# 1963 - 1967 Corvette: Service News: Corvette Coupe Body Rework for Larger Racing Tires (Rear Wheels)

**Subject:** Corvette Coupe Body Rework for Larger Racing Tires (Rear Wheels)

**Source:** Chevrolet Service News

**Date:** August 1964, Volume 36, Issue Number 7

Fig. 2—Rework of 1963-64 Corvette Model 837 for Installation of Larger Tires

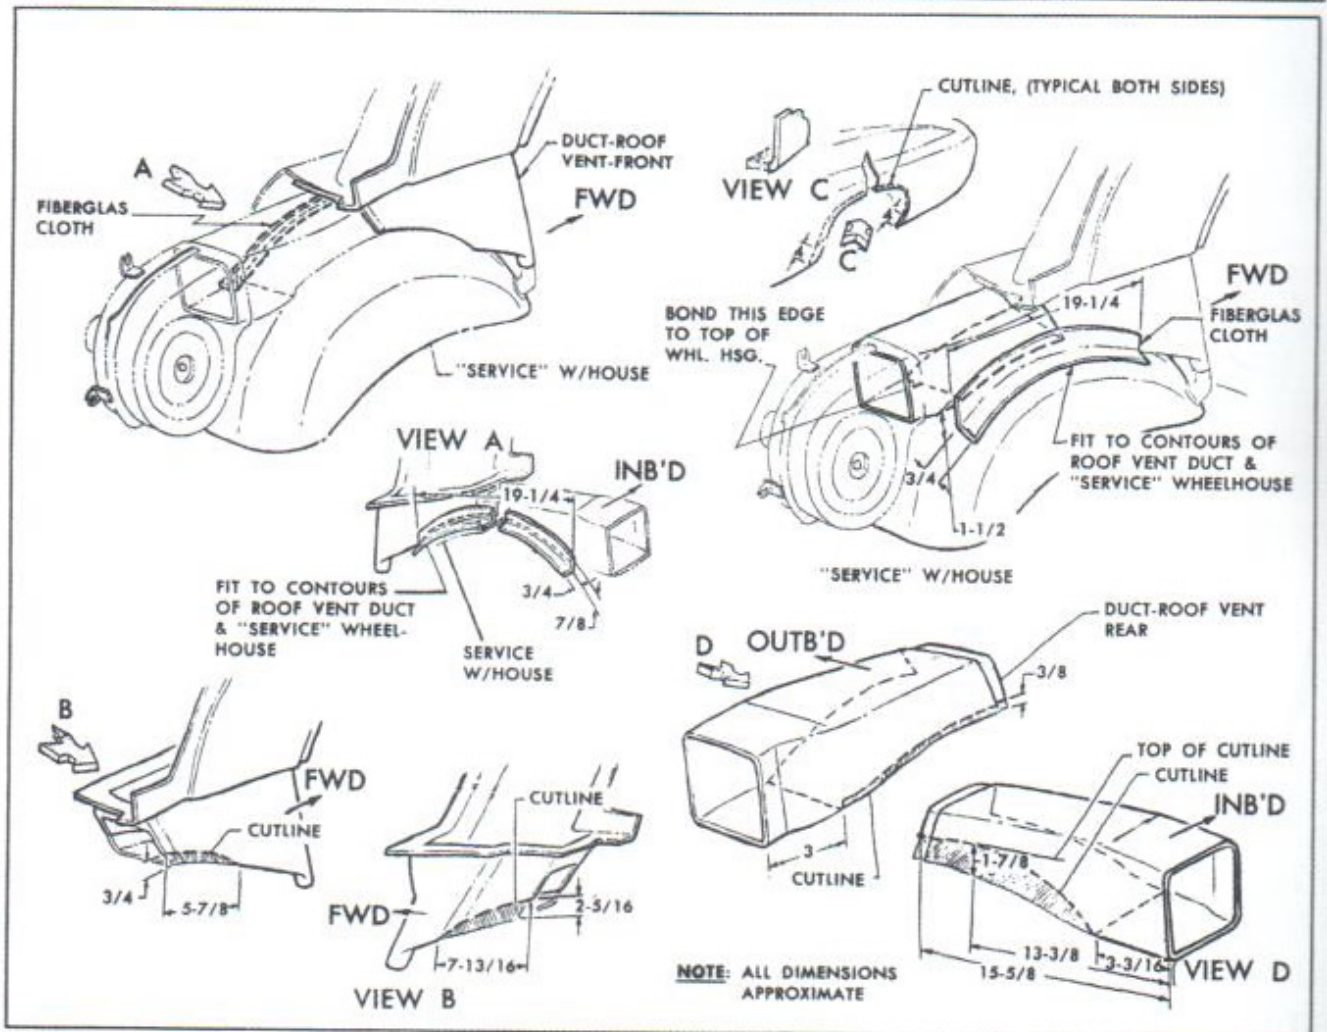
Refer to Figure 2 for details of the installation of the larger wheel housings, the provision of extra clearance between the tire and wheel openings, and the

modification of the body rear compartment air exhaust duct. In those areas where cutting and rebonding of fiberglass is involved, regular shop practices and materials should be used. The use of the materials show in Group 12,800 of the Chevrolet Parts Catalog is suggested.
